**RE: Addendum to the Contract Documents for the West High Service Pump Station
Bid No. ITB-4221**

**ADDENDUM NO. 2
TO
BID DOCUMENTS
FOR
WEST HIGH SERVICE PUMP STATION
FOR THE
CITY OF ANN ARBOR, MICHIGAN**

The following changes, additions, and/or deletions shall be made to the Bid Documents for the West High Service Pump Station Project for the City of Ann Arbor, Michigan, Bid No. ITB – 4221 on which bids were to be received, on or before, 10:00 A.M. Thursday, May 31, 2012.

E-122

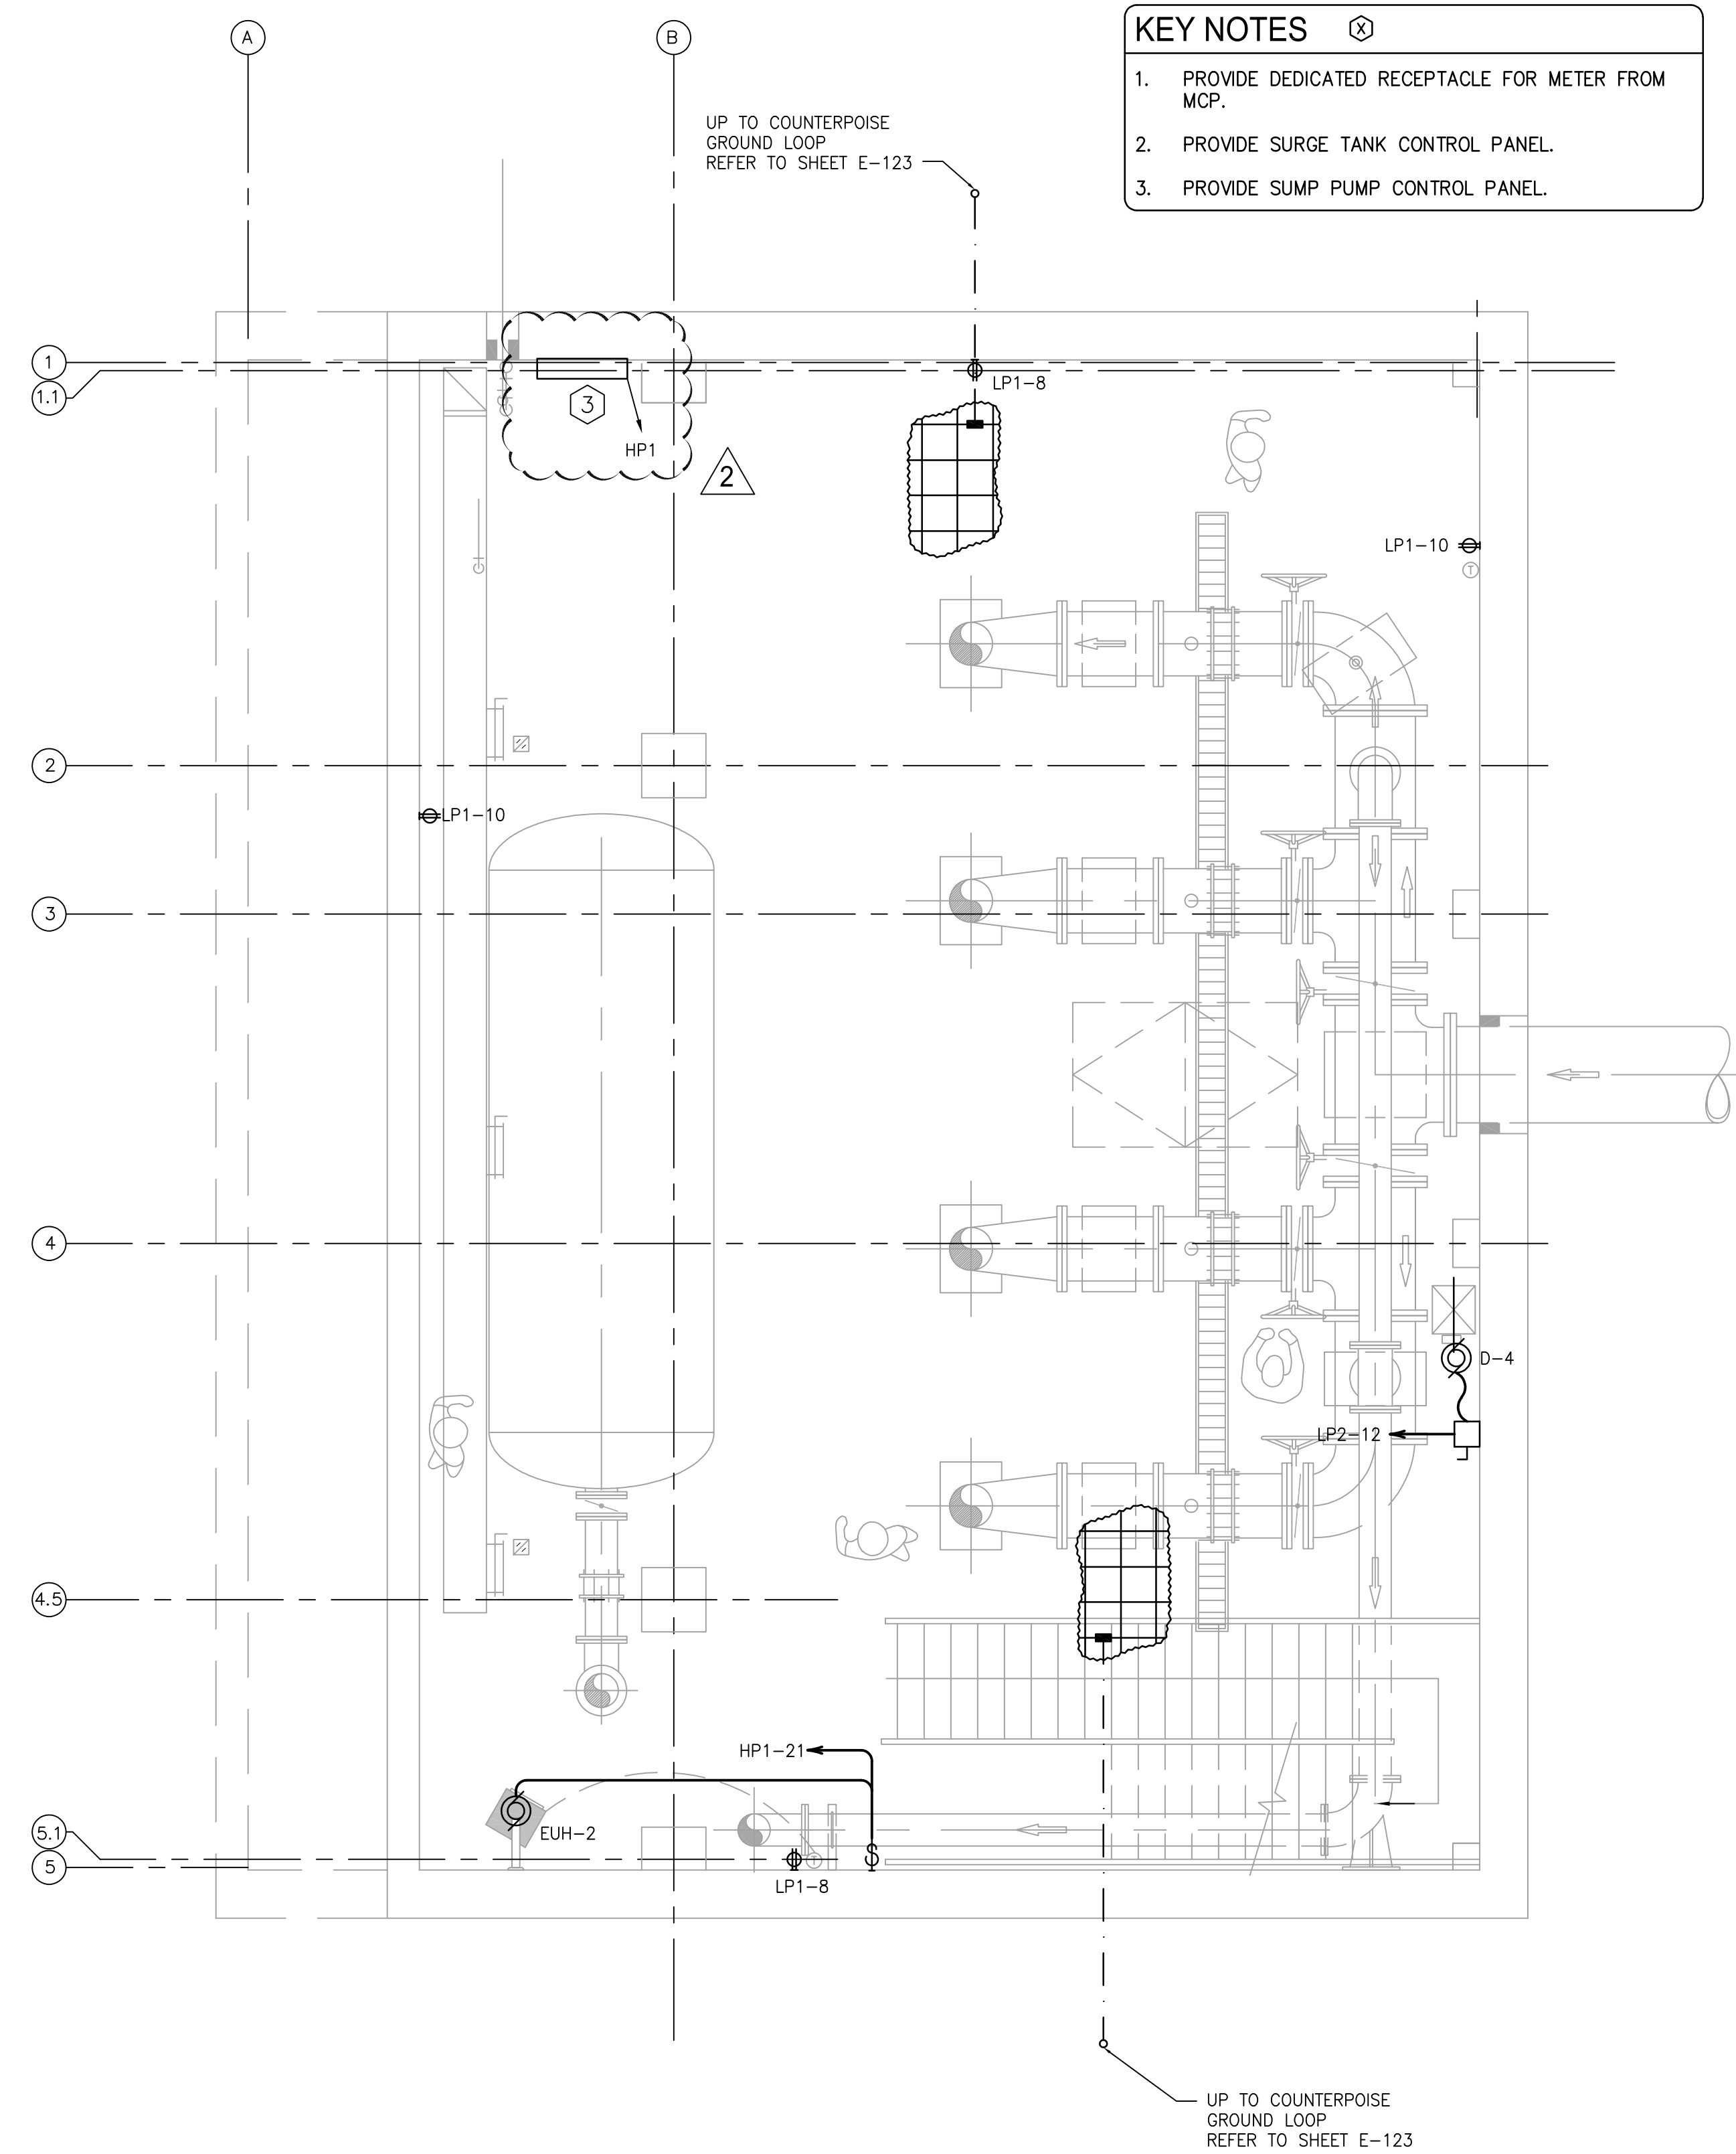
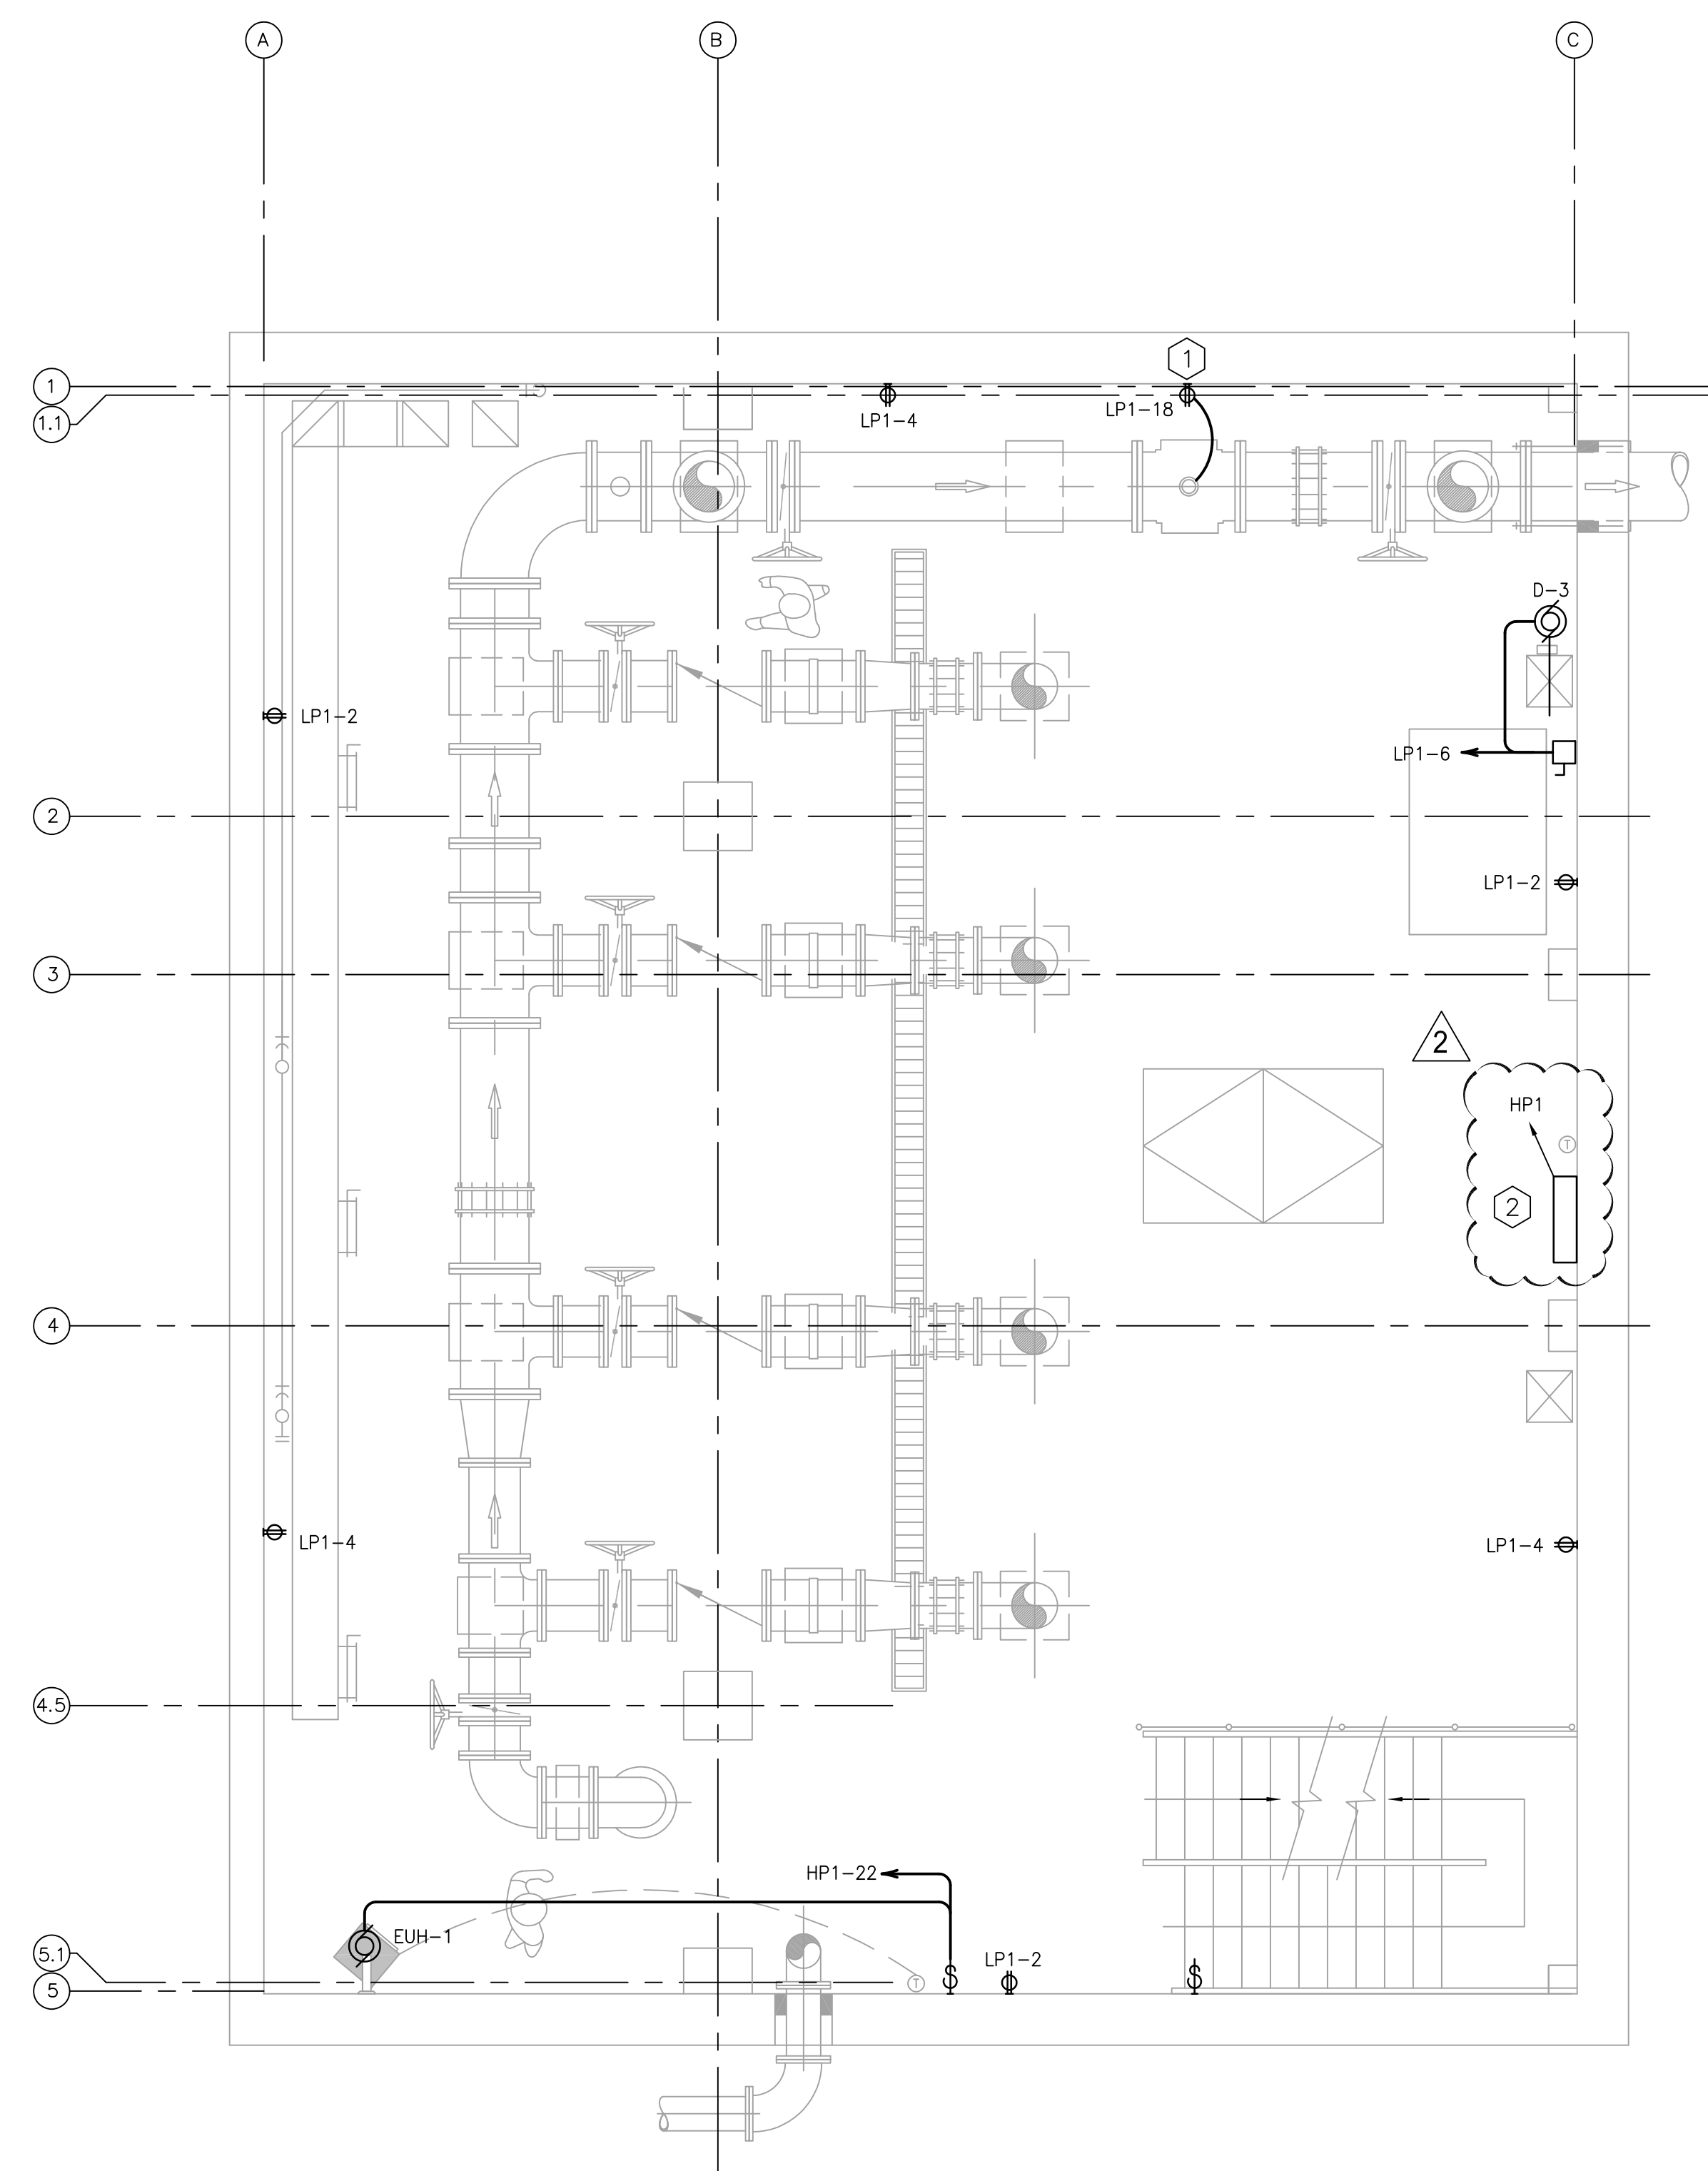
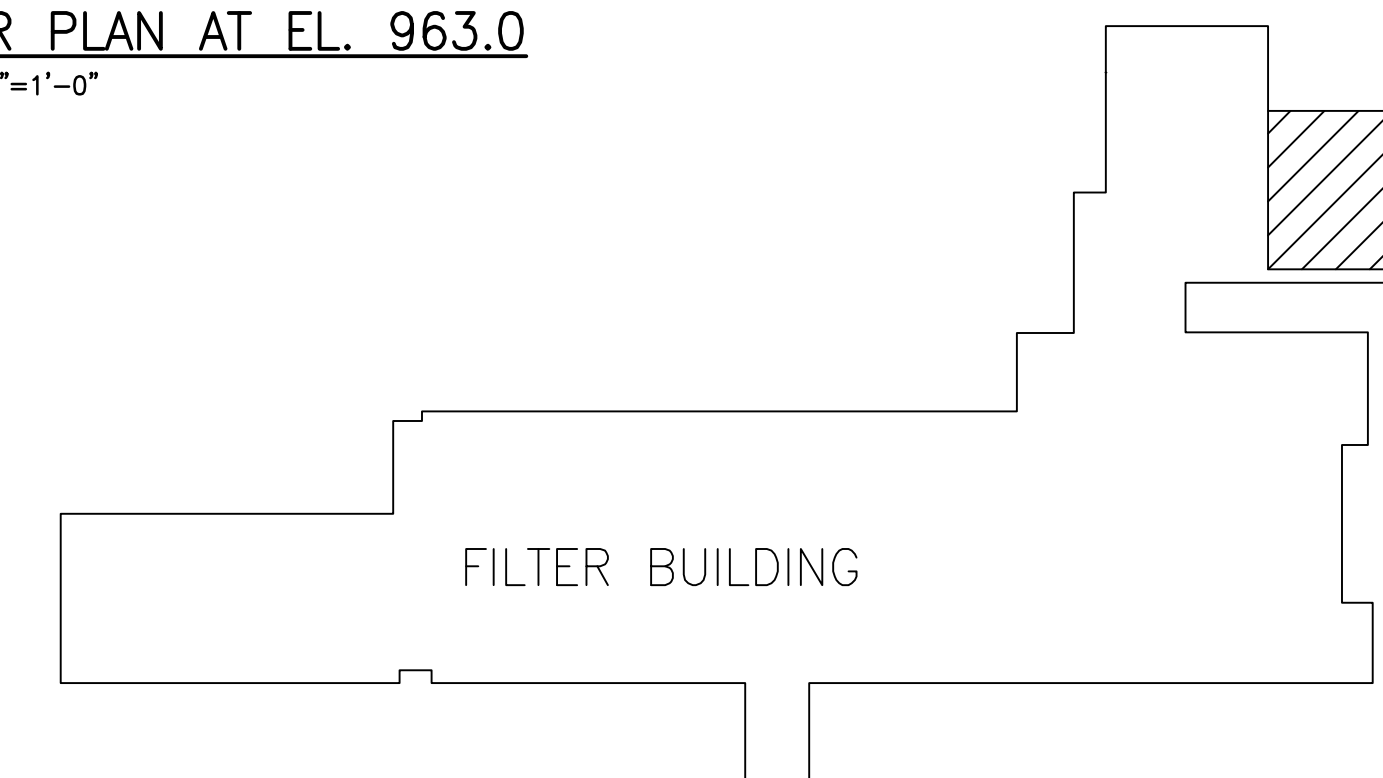
Revise Drawing E-122 to show the homeruns for electrical feeders to the sump pumps and surge tank control panel.
